BID ADDENDUM NO.1

2181539 Bank on Buffalo, Niagara Falls, NY

There was an error during the printing process that caused the structural & HVAC items to not appear in the Architectural drawings. Some of the drawings being replaced are only to show the missing items for clarification. No actual changes are occurring on these sheets. Any changes to the drawings are clouded & tagged.

3 WALL SECTION - EAST
A311 SCALE: 3/4" = 1'-0"

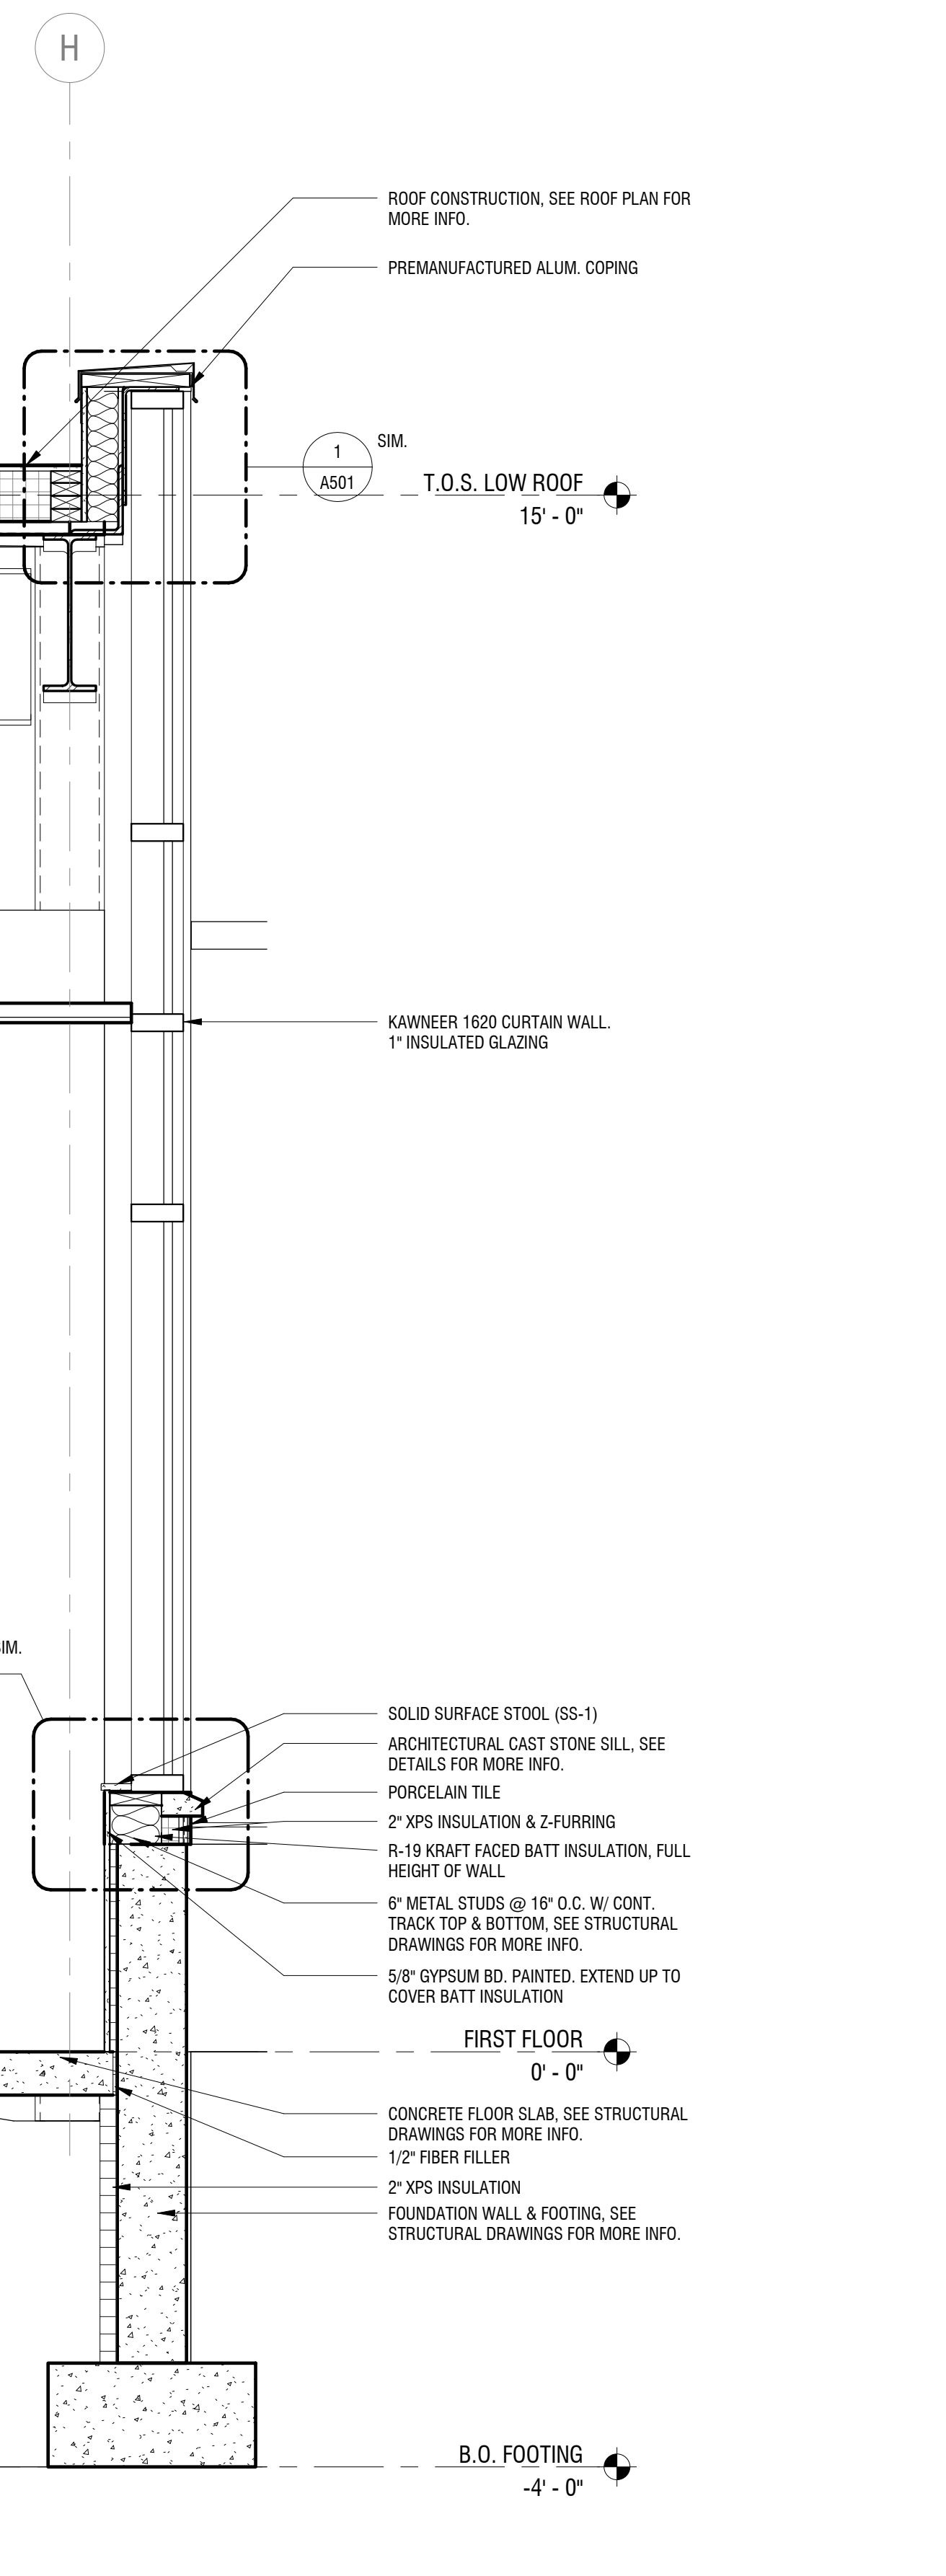
- J. Drawing A311**
 - 1. DELETE Drawing in its entirety
 - 2. ADD replacement Drawing A311
 - 3. HVAC & structural shown on drawings.

A312

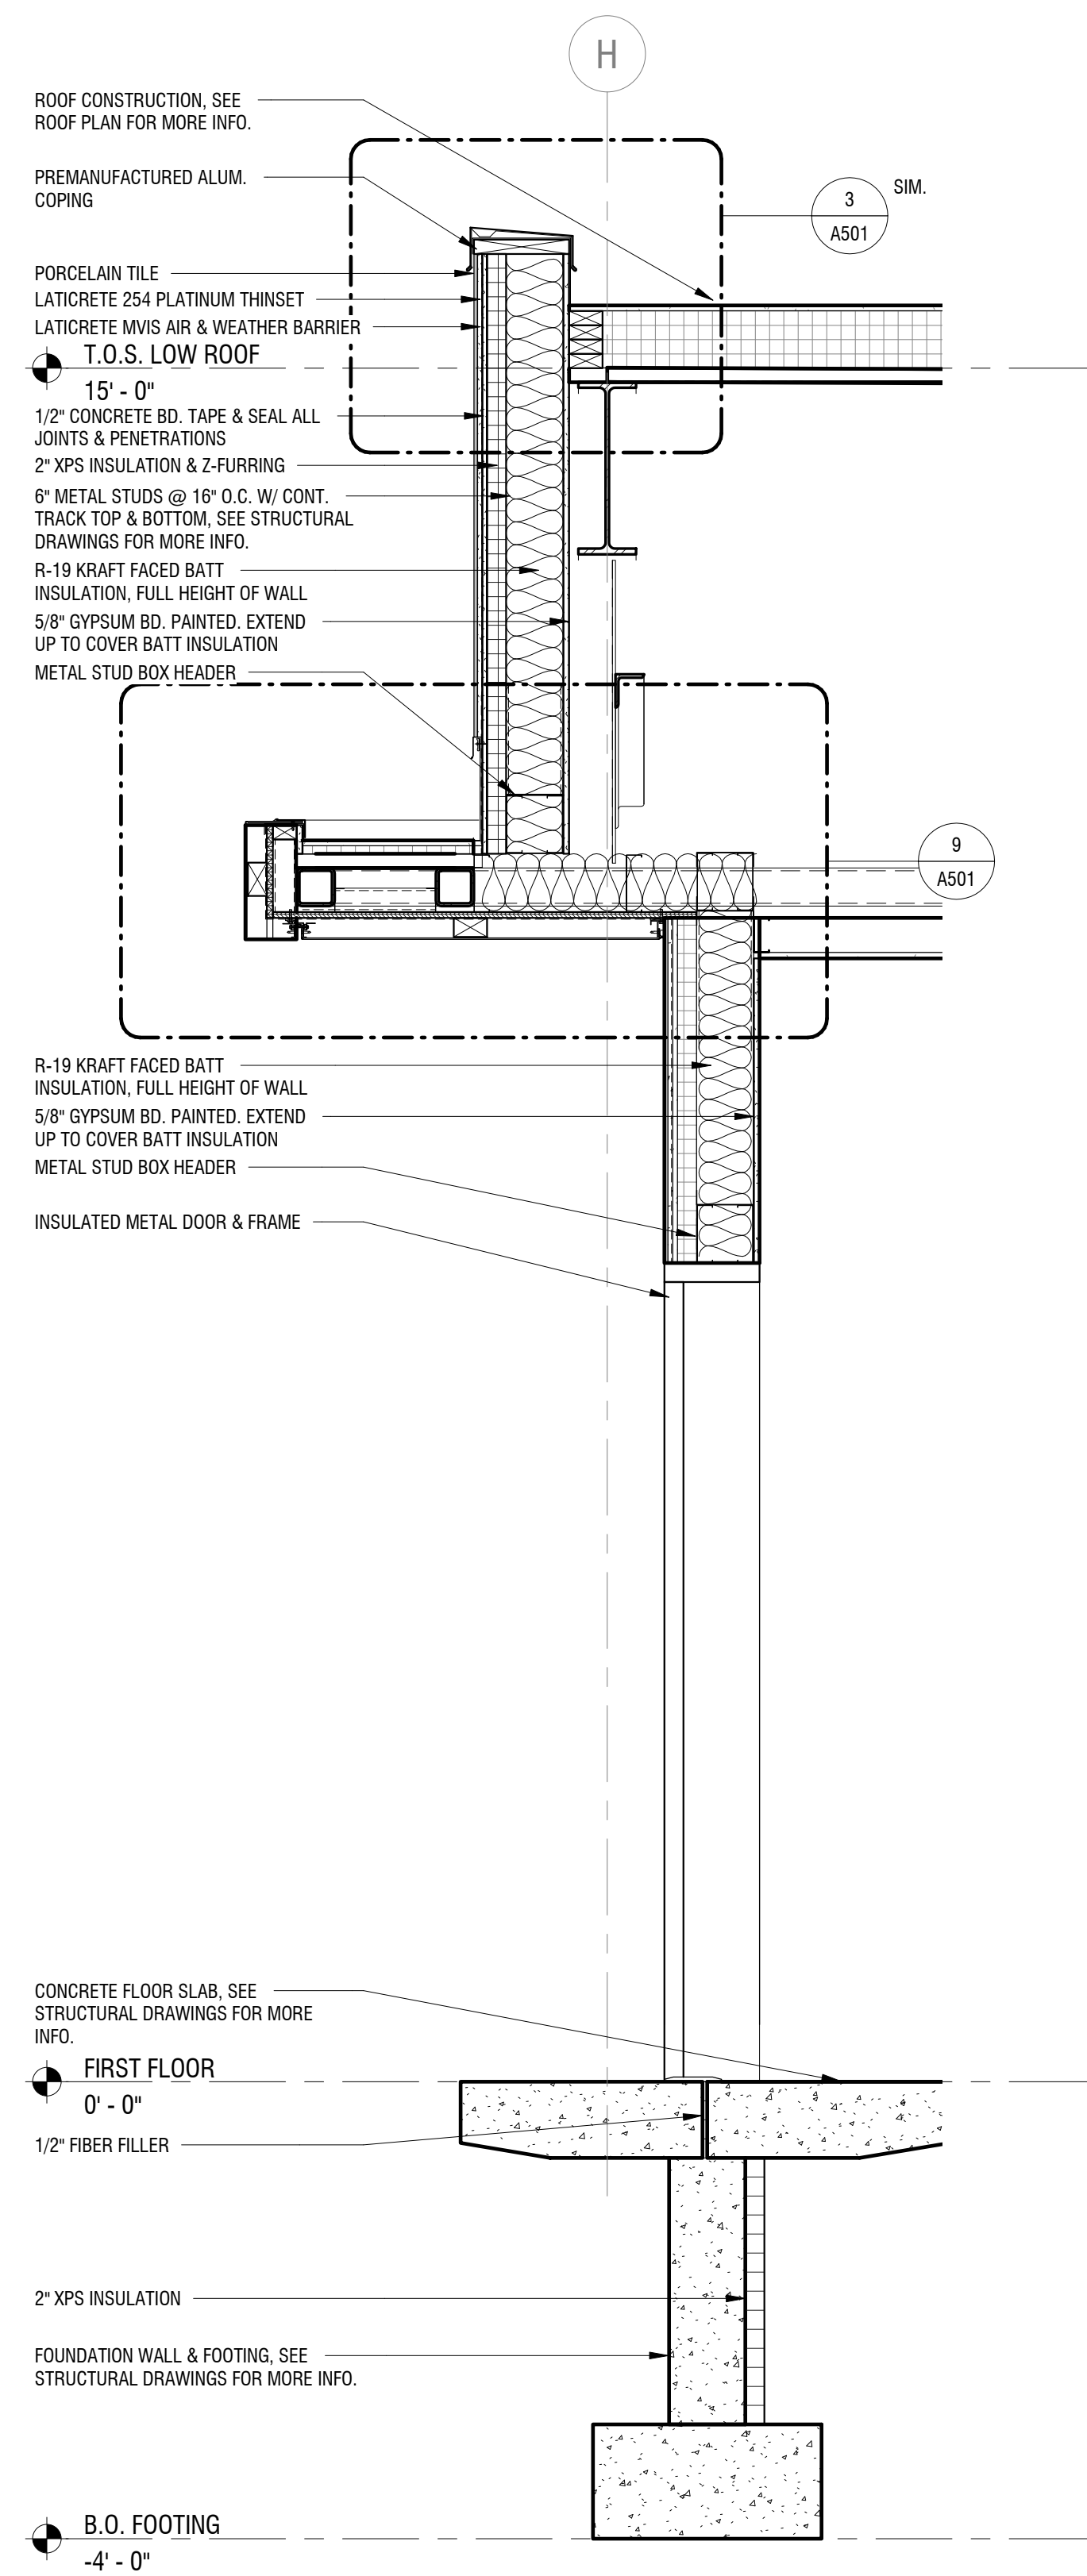
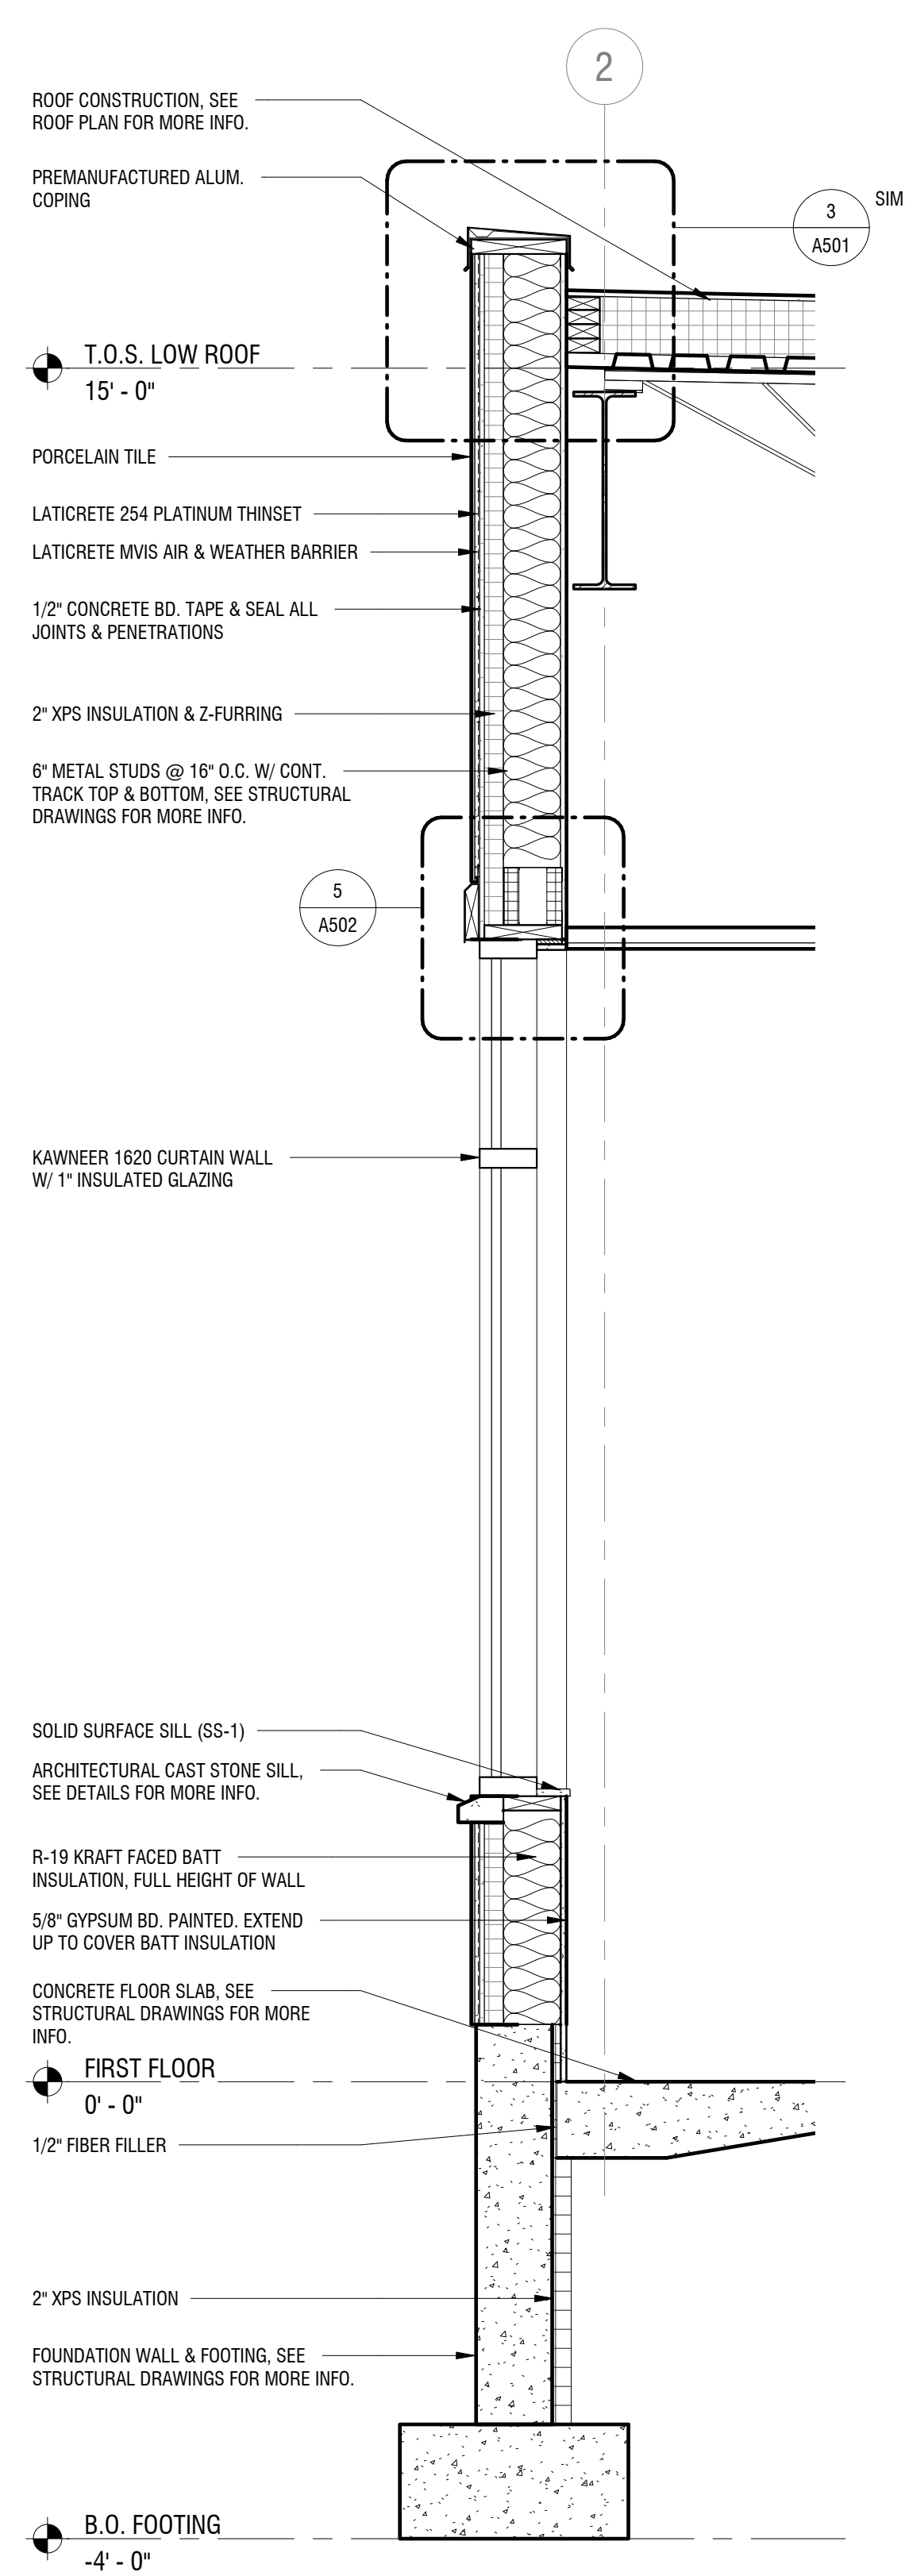
- K. Drawing A312**
 - 1. DELETE Drawing in its entirety
 - 2. ADD replacement Drawing A312
 - 3. HVAC & structural shown on drawings.
